Detailed Site Plan Alternative Compliance Giac Son Buddhist Temple

DSP-20002
AC-22009

STAFF REPORT

SUBJECT: Detailed Site Plan DSP-20002
 Type 2 Tree Conservation Plan TCP2-018-2023
 Alternative Compliance AC-22009
 Giac Son Buddhist Temple

Figure 2: Institutional Building-Mounted Signage

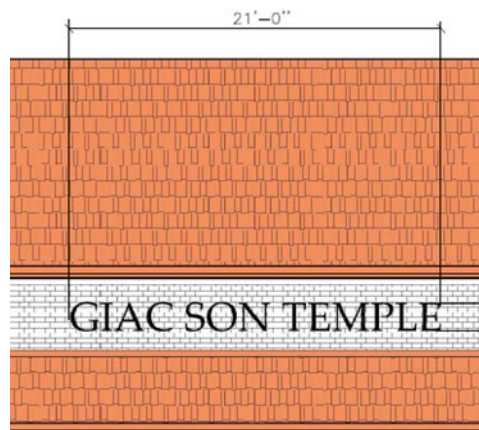
Both building-mounted and freestanding signage are proposed for this project. A 21-foot-long by 1.5-foot-high lettered sign that reads “GIAC SON TEMPLE” is proposed to be mounted along the building’s front elevation facing MD 197. Freestanding signage is proposed along the corner of the intersection of MD 197 and Snowden Road. The signage will consist of 6-inch, painted orange letters that read “Giac Son Buddhist Temple.” The letters will be mounted on a rough-hewn, granite, monolith stone that is 4 feet long and 6 feet high. Staff find the proposed signage to be sufficient, subject to a condition that requires the applicant to modify the architectural elevations and signage sheets to create a signage chart on the DSP coversheet. The signage chart should list the maximum permitted signage area and the applicant’s proposed signage area for both signs. In addition, the code references provided by the applicant are incorrect. The signage is permitted by Section 27-617 of the prior Zoning Ordinance, which allows one freestanding or attached sign per street frontage for the property. The materials that both signs will be constructed of shall be clearly identified, and the applicant shall provide a colored rendering of the proposed freestanding sign.

- j. Revise the architectural elevations on Sheet 7 to clearly label the material of the proposed attached signage.
- k. Provide a colored rendering of the freestanding signage proposed on Sheet 10.
